REV.
B

AS5423

HOSE ASSEMBLY, LINED SILICONE, HEATED, FLARELESS TO FIXED CAVITY, 125 PSI, POTABLE WATER

ISSUED 2000-07 REAFFIRMED 2013-01 REVISED 2013-09

FIGURE 5 - STYLE C1

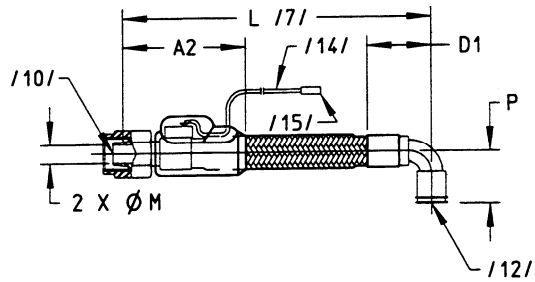
REACH DIMENSIONS C1 AND F1 WERE REVISED FROM "MIN" TO "MAX" BECAUSE THIS IS MAXIMUM LENGTH OF THE FITTING. A TOLERANCE WAS ADDED TO THE LEADWIRE LENGTH.
